CS Memorandum No. 1346

To: Distribution
From: Susan MacKenzie, Document Control Manager 
Date: January 30, 2013
Reference: Project No. M544.1, Contract No. CS-149
Task No. 1-8.02, Change Control
Subject: Configuration Management Board Meeting No. 111

CMB Meeting Minutes #111

SUBJECT: Configuration Management Board Meeting # 111 – Rev. No. 0

Attachments Attach. No.1 - Sketch for approximate footprint dimensions

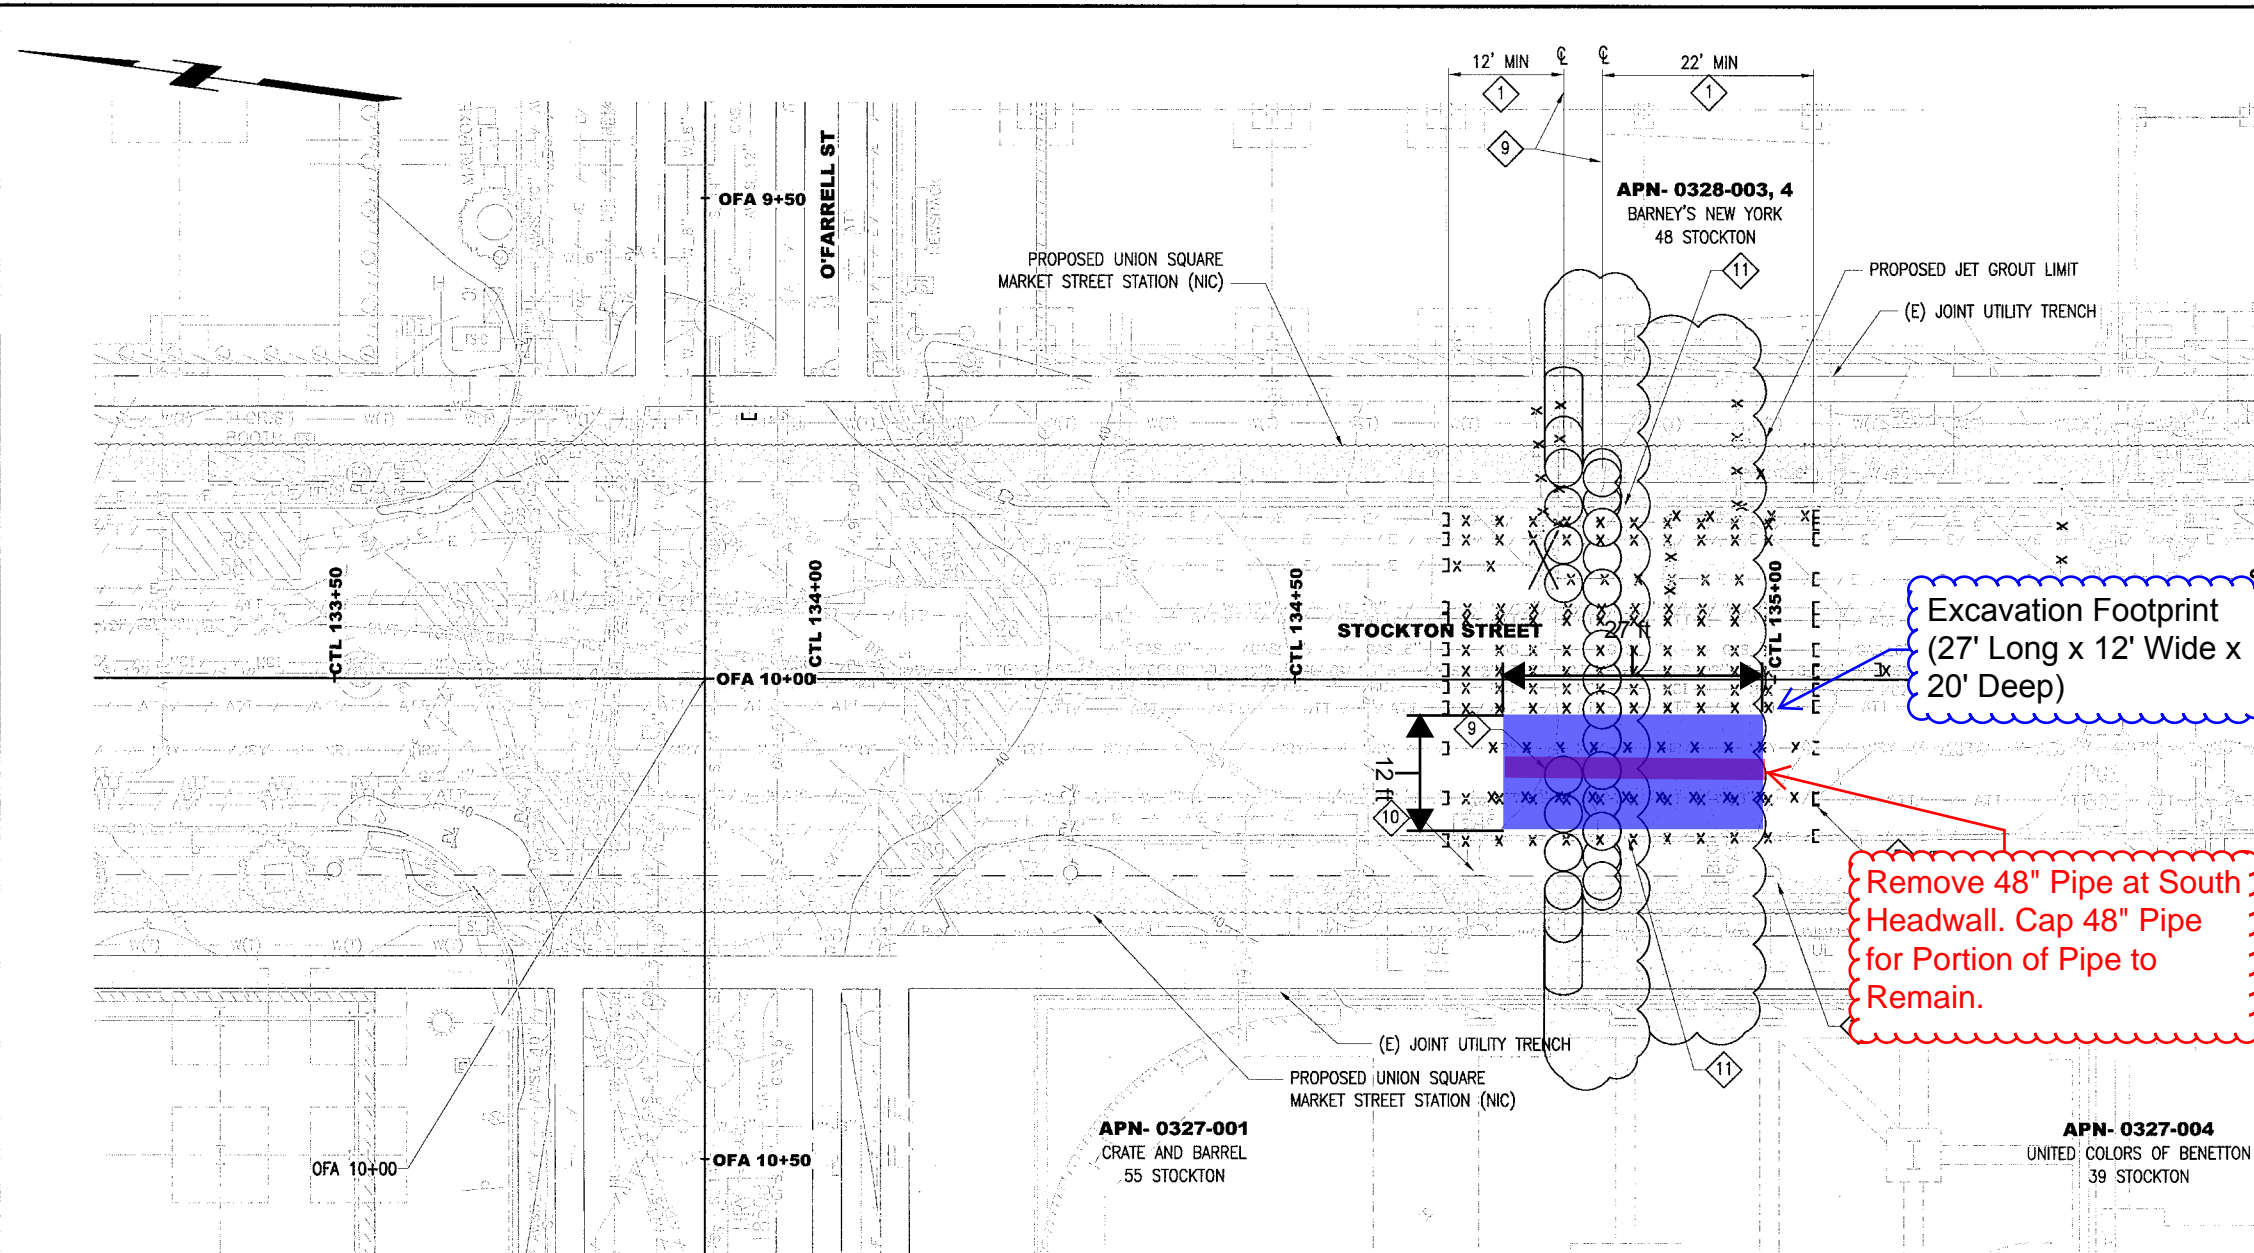
1. Complete additional excavation and shoring necessary to expose the 48" pipeline within the construction limits at the south headwall.
2. Cut and remove the 48" steel pipe at the south headwall.

3. Install steel bulkheads at each end of the 48" pipe that remains at the south headwall.
4. Backfill the excavation and remove shoring at the south headwall.

7. Cut and remove the 48" steel pipe at the north headwall.
8. Install steel bulkheads at each end of the 48" pipe that remains at the north headwall.
9. Backfill the excavation and remove shoring at the north headwall.
